Agenda
Village of Arlington Heights
Design Commission
Community Room, 3rd Floor

Arlington Heights Village Hall
33 S. Arlington Heights Road
Arlington Heights, IL 60005
August 26, 2014
6:30 PM

DATE: August 26, 2014
TO: Chairman Eckhardt and Members of the Design Commission
FROM: Steve Hautzinger, Design Planner
RE: **DC Number: 14-058, Hickory/Kensington Area Design Guidelines**

SCALE: 1" = 20' 0"

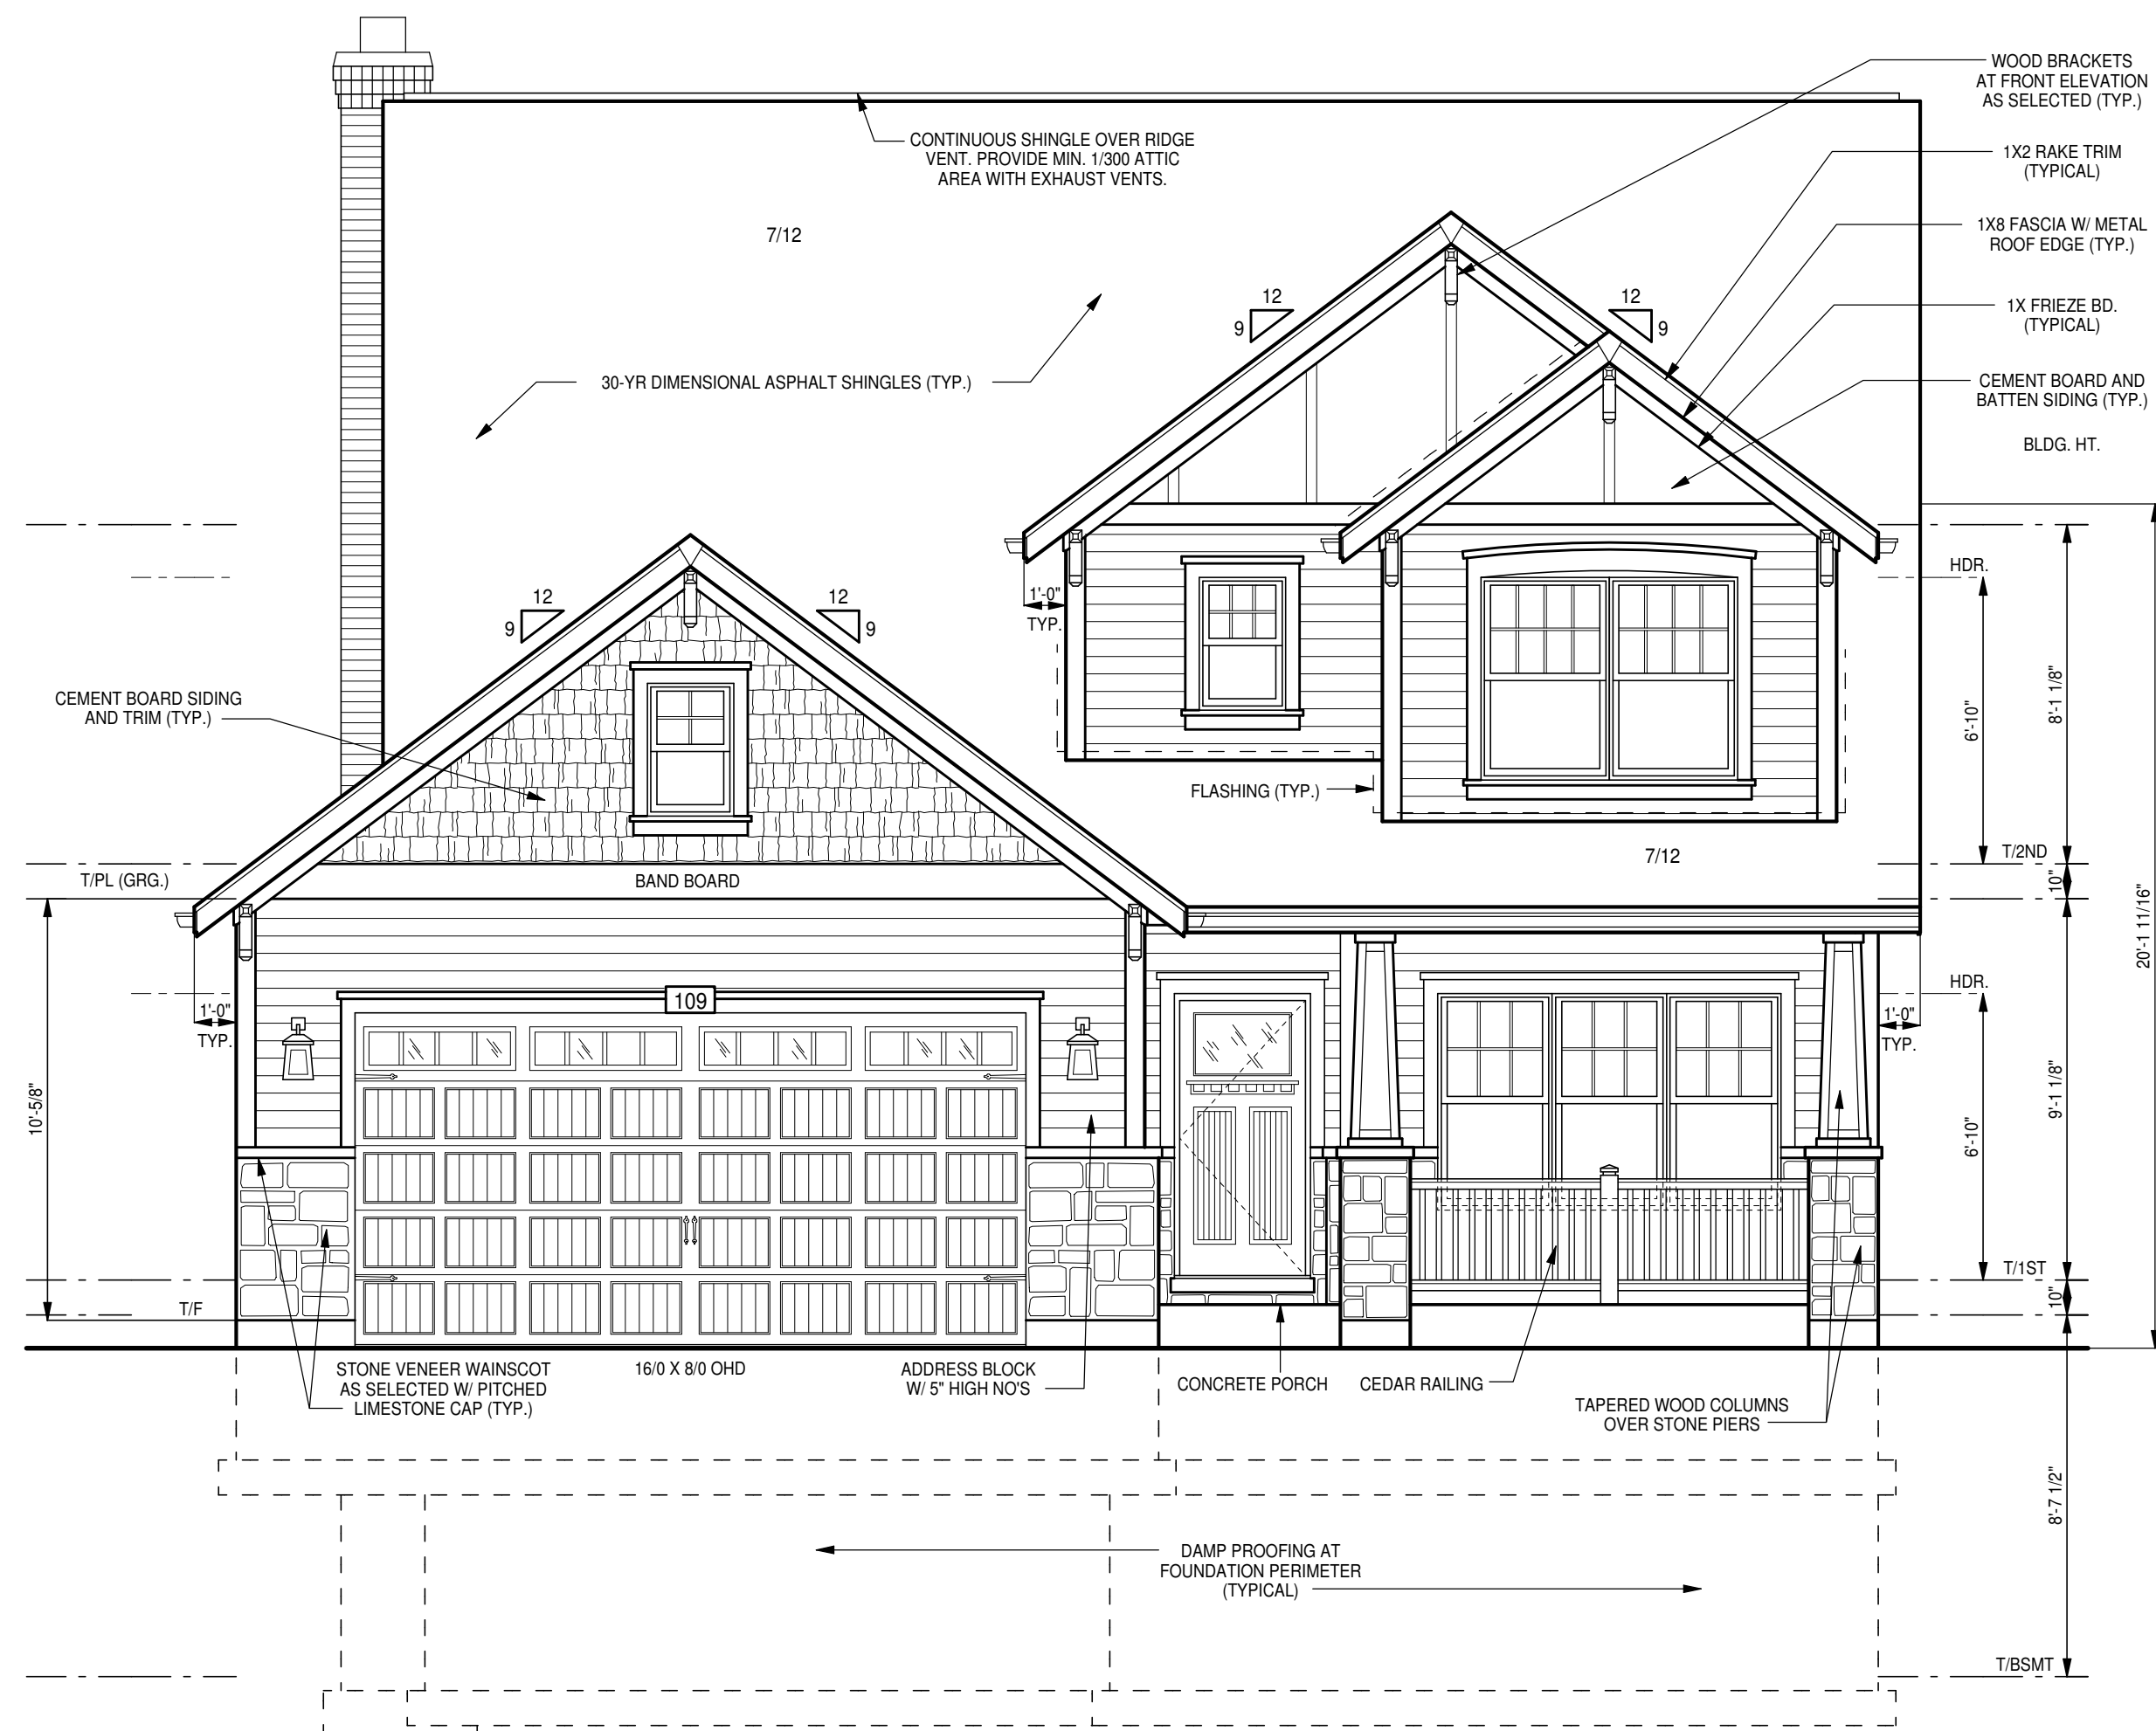
It is recommended that the Design Commission evaluate the proposed new single-family residence to be located at 815 N. Kaspar Avenue. This recommendation is subject to compliance with the architectural plans received 7/30/14, and the following:

1 EAST ELEVATION
SCALE: 1/8" = 1'-0"

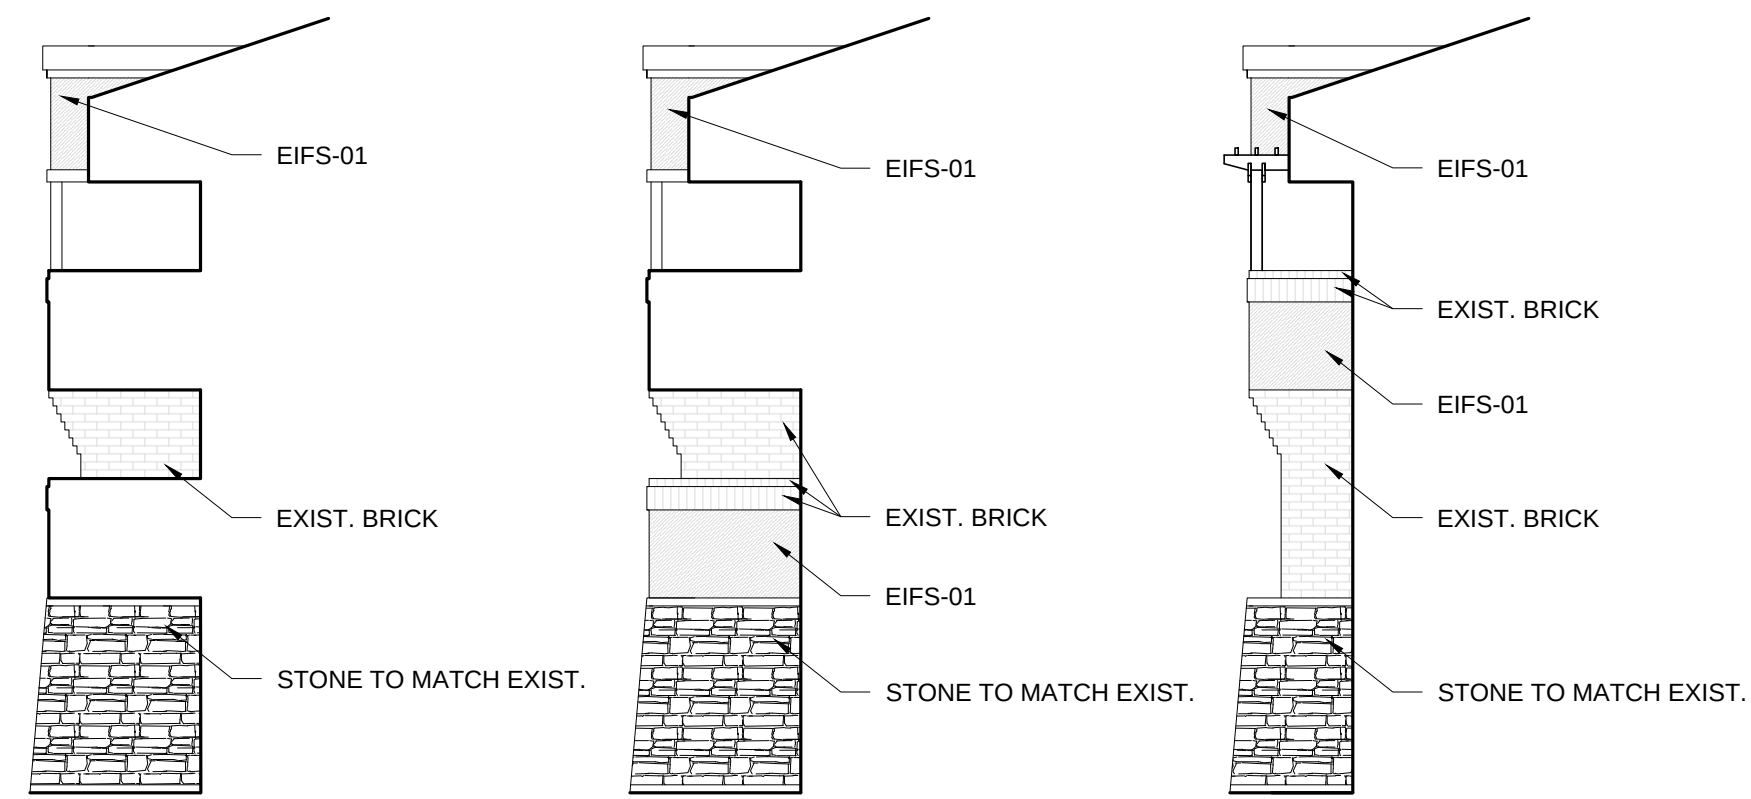
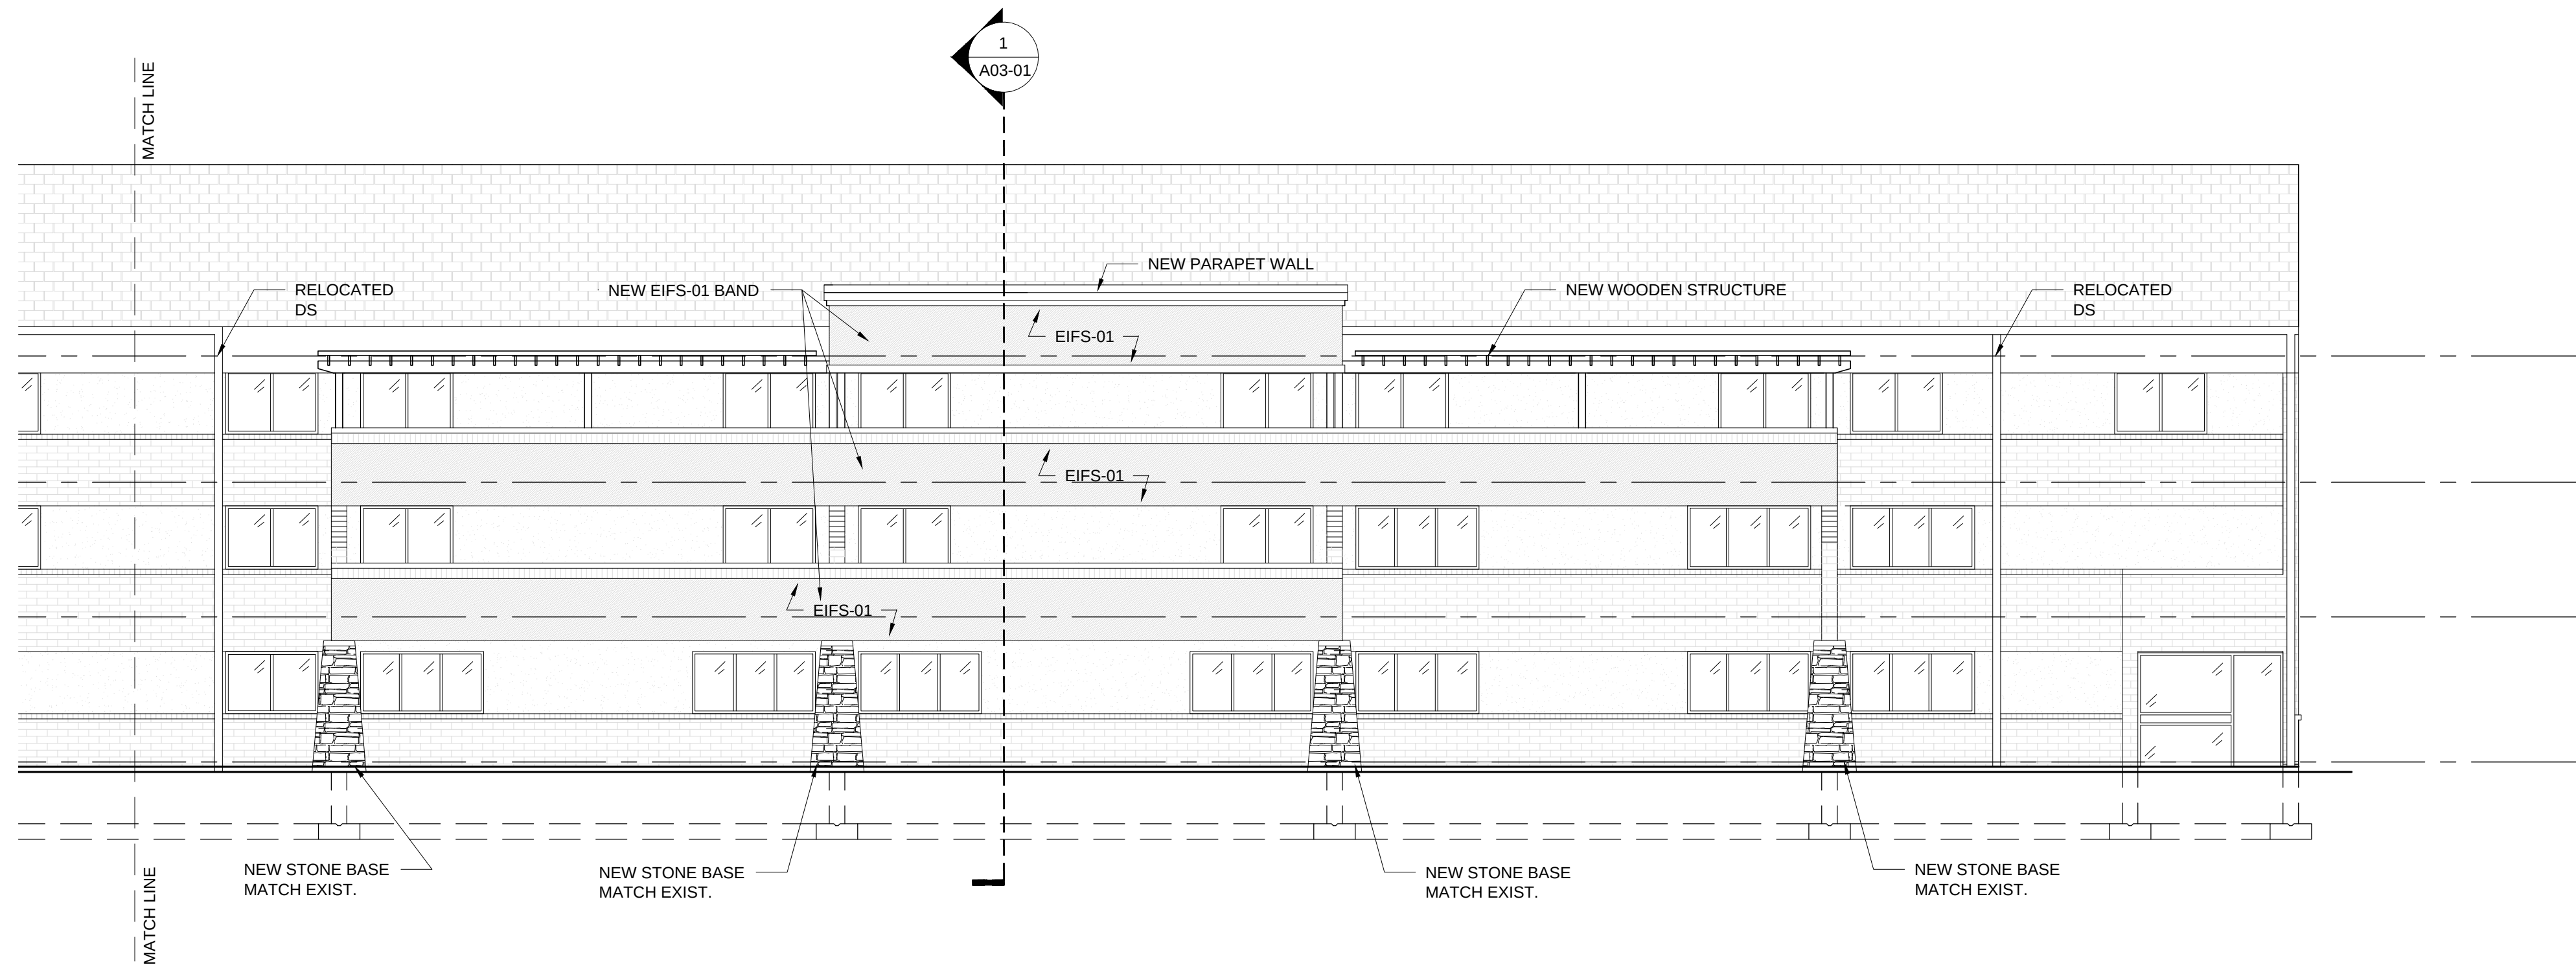
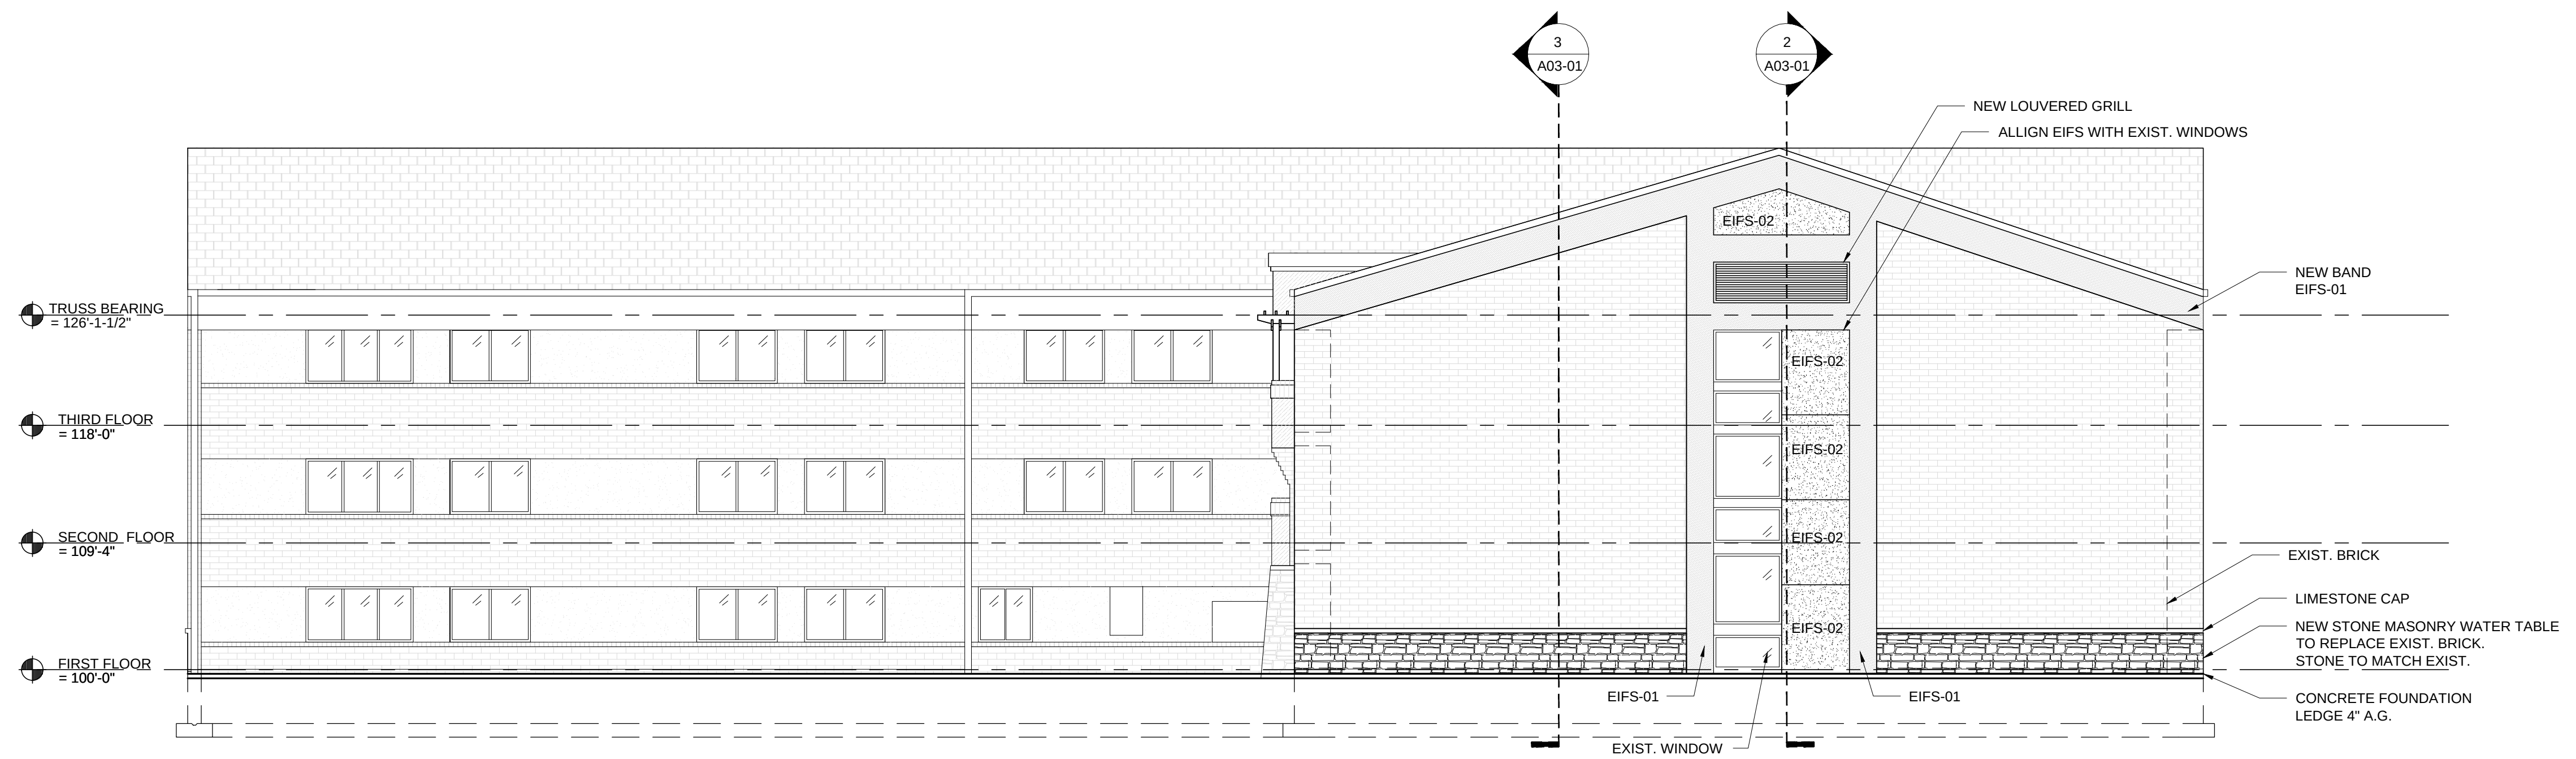
The proposed modifications will be a nice improvement to the existing building design. Specifically, the existing east façade is a large brick wall with little detail or interest. The east façade is highly visible from Arlington heights Road, and the proposed changes will improve the curb appeal of the building.

It is recommended that the Design Commission **approve** the proposed architectural design for exterior modifications to the *Comfort Inn Hotel* located at 2120 S. Arlington Heights Road. This recommendation is subject to compliance with the plans dated 8/6/14 and received 8/8/14, Design Commission recommendations, compliance with all applicable Federal, State, and Village codes regulations and policies, the issuance of all required permits, and the following:
